Access Compliance Report

Public Rights-of-Way

Intersection ID: 44057	Main Street: HOLLAND_PARK_LN	Cross Street: LONGSTONE_LN	Location:	N
ADA ID: 03A6A74CB95C	Ramp Type: PerpDiag	Initial Pass/Fail: Fail	Overall Compliance: No	Severity Score: 60

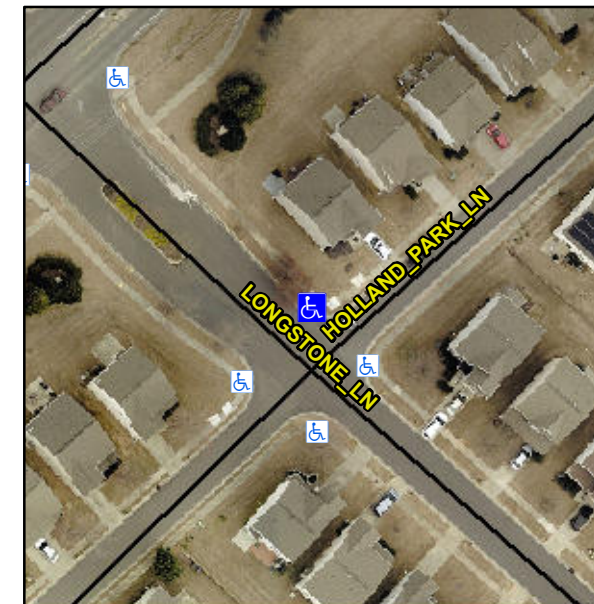
Not Found, R304.5.1, R304.5.3

Compliance	Description	Data	Compliance	Description	Data
N/A	Ramp Length (in)	71.5	Yes	Ramp Slope (%)	6.8
No	Ramp Width (in)	28.0	No	Ramp XSlope (%)	7.2
N/A	Flare Type LT	N/A	N/A	Flare Type RT	N/A
N/A	Flare Slope LT (%)	N/A	N/A	Flare Slope RT (%)	N/A
N/A	Flare Traversable LT?	N/A	N/A	Flare Traversable RT?	N/A
N/A	Landing Length (in)	N/A	N/A	DWS Provided?	N/A
N/A	Landing Width (in)	N/A	N/A	DWS Contrast?	N/A
N/A	Landing Slope (%)	N/A	N/A	DWS Length (in)	N/A
N/A	Landing X Slope (%)	N/A	N/A	DWS Full Width?	N/A
N/A	Landing Curb? (Y/N)	N/A	N/A	DWS Offset (in)	N/A
N/A	Shared Landing?	N/A			
N/A	Gutter Ponding?	N/A	N/A	Gutter Slope (%)	N/A
N/A	Gutter Lip Ht (in)	N/A	N/A	Gutter X Slope (%)	N/A
N/A	Painted X Walk1?	No	N/A	Painted X Walk2?	No
	X Walk 1 Direction	To SW		X Walk 2 Direction	To SE
N/A	X Walk 1 Width (in)	N/A	N/A	X Walk 2 Width (in)	N/A
	X Walk 1 Slope (%)	1.2		X Walk 2 Slope (%)	6.5
	X Walk 1 X Slope (%)	6.5		X Walk 2 X Slope (%)	0.5

Remove & Replace Curb Ramp With Two New Directional Ramps or Equivalent.
